PRODUCT TOOL PT-18

Rotron Muffler foam change

BASE MOUNT

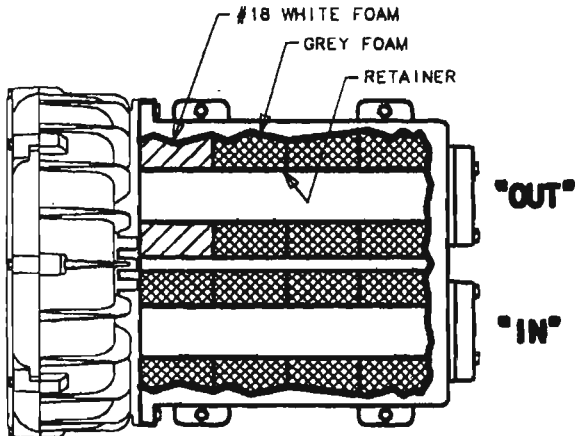
In an effort to improve our products, we are eliminating the acoustical fiberglass muffler material. This has been replaced with acoustical foam. In each muffler tower there are pieces of white foam. This foam is to be placed nearest the impeller in the outlet side of the muffler tower. The white foam piece is a high temperature version which needs to be placed as shown below.

PLACE WHITE FOAM INSERT (#18) NEXT TO HOUSING, IN "OUT" PORT OF MUFFLER TOWER AS SHOWN.
